From: James, Kamilah
Sent: Thursday, October 02, 2008 8:59 AM
To: Luis.Valdez@helixwater.org
Cc: 'Tim Stanton'
Subject: Submittal to the Wet Utilities Subcommittee - Item 2008-11
Attachments: 2008-11 B.pdf; 2008-11 A.pdf

Attached please find proposed revisions to WV-01 & WV-02. These were submitted to the Regional Standards Committee by John Thomas, County of San Diego and Bud Oliveira, City of Escondido. Please review and bring your subcommittee's recommendation to the general committee.

GATE WELL CAP INSTALLATION, FOR VALVES 100mm (4") AND LARGER

GATE WELL CAP & CAN INSTALLATION,
 FOR VALVES 100mm (4") AND LARGER

DRAWING NUMBER **WV-01**

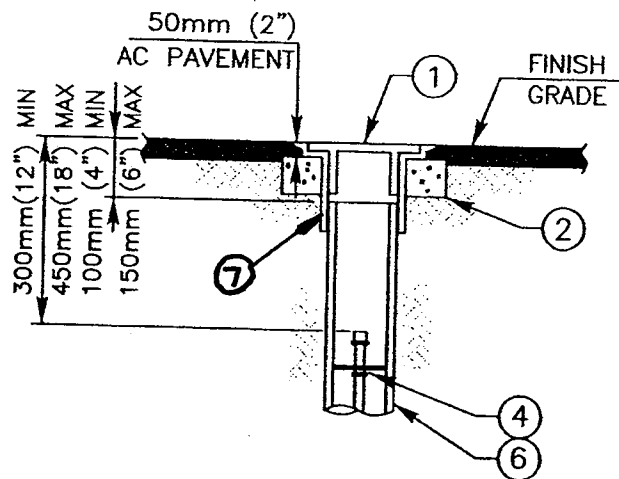
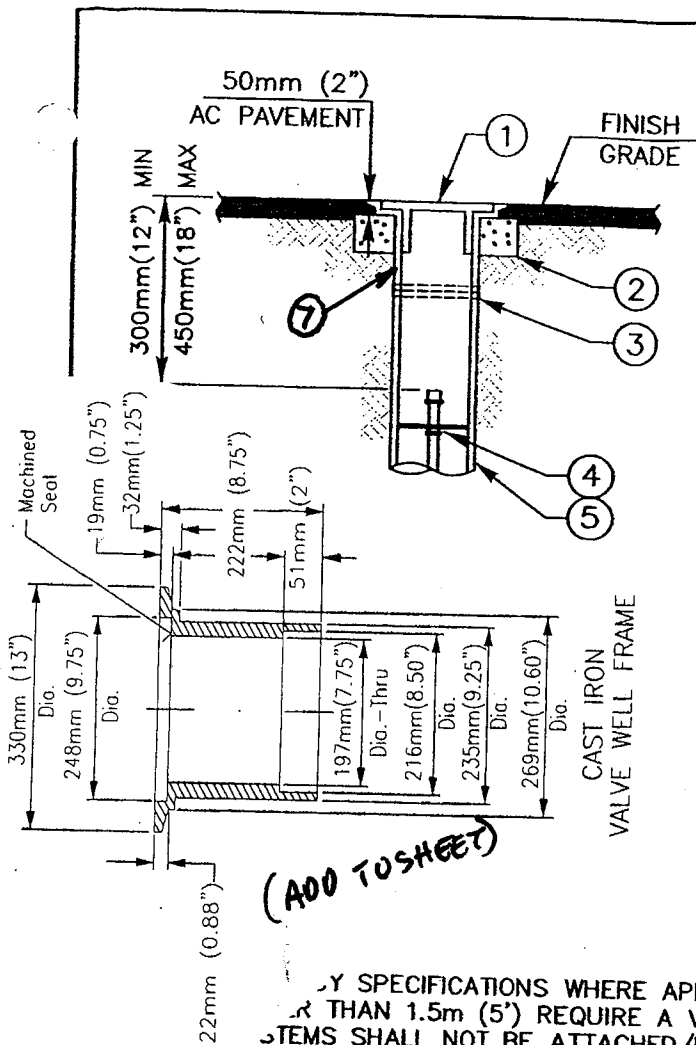
ITEM NO	SIZE AND DESCRIPTION	ITEM NO	SIZE AND DESCRIPTION
①	GATE WELL WITH CAP SEE NOTE 7	④	200mm (8") PVC CL 200, C-900 PIPE x REQUIRED LENGTH GATE WELL SEE NOTE 7
②	150mm (6") HIGH x 150mm (6") WIDE COMPACTED ASPHALT CONCRETE RING	⑤	BUTTERFLY VALVE
③	VALVE STEM EXTENSION SEE NOTES 2 & 3	⑥	RESILIENT WEDGE GATE VALVE
⑧	CAST IRON VALVE WELL FRAME PER WV-02	⑦	WATER MAIN

DRAWING
 NUMBER **WV-02**

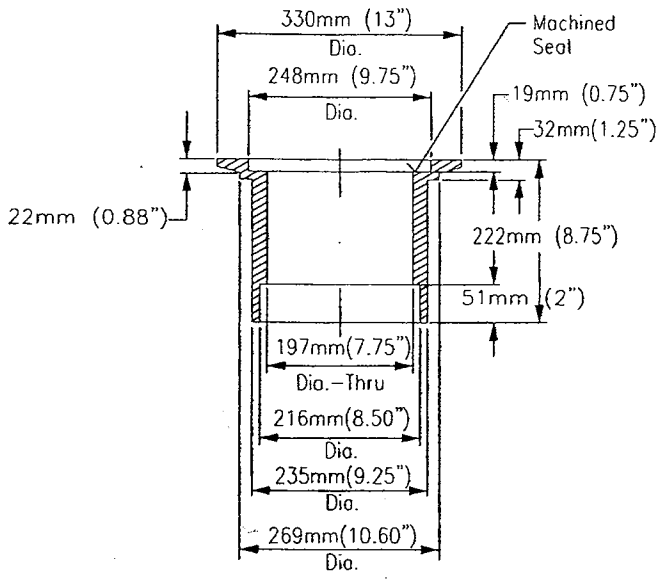
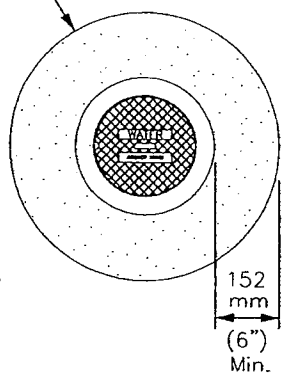
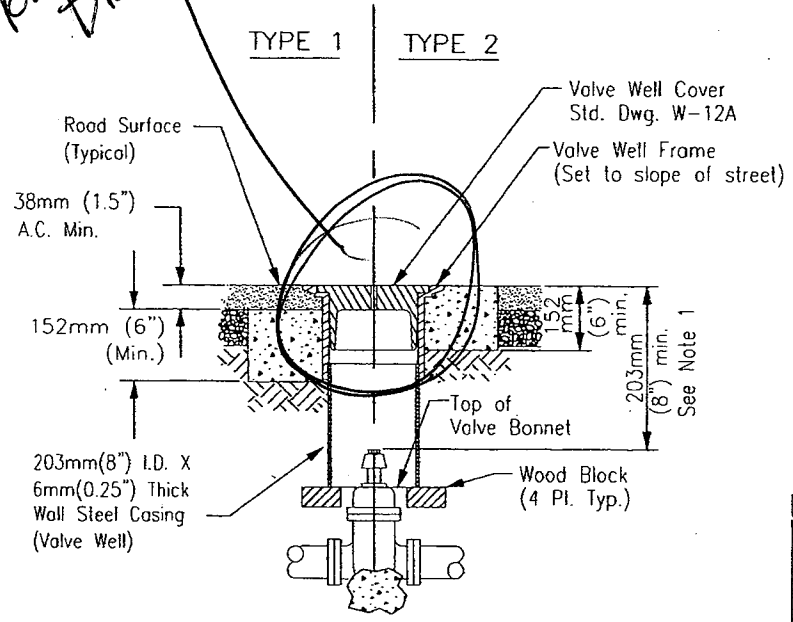
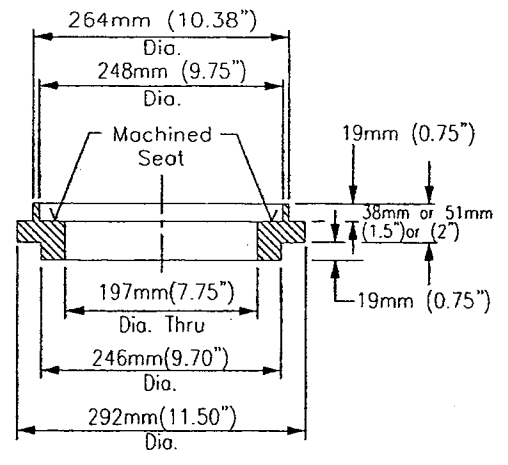
6" GATE WELL TYPE B

KEEP LID &
SEAT IN
REVISION
DRAWING.

DRAWING NUMBER W-12B

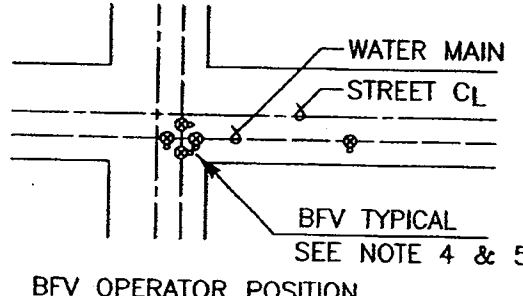
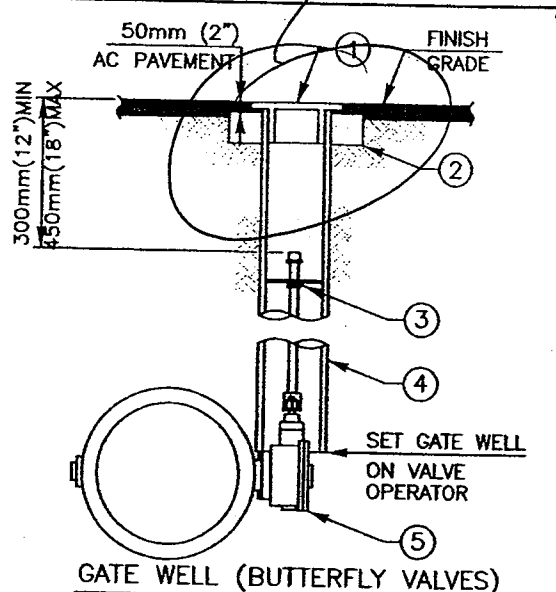
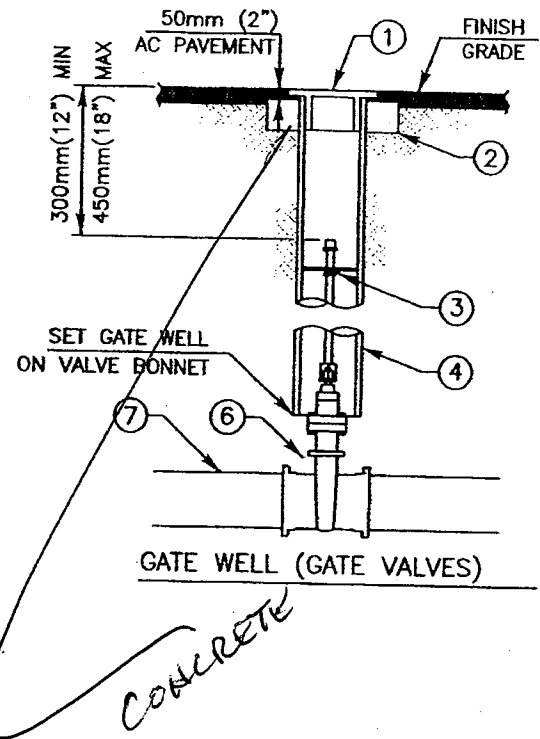
KEEP LID & SEAT (SAME AS W 12-13)
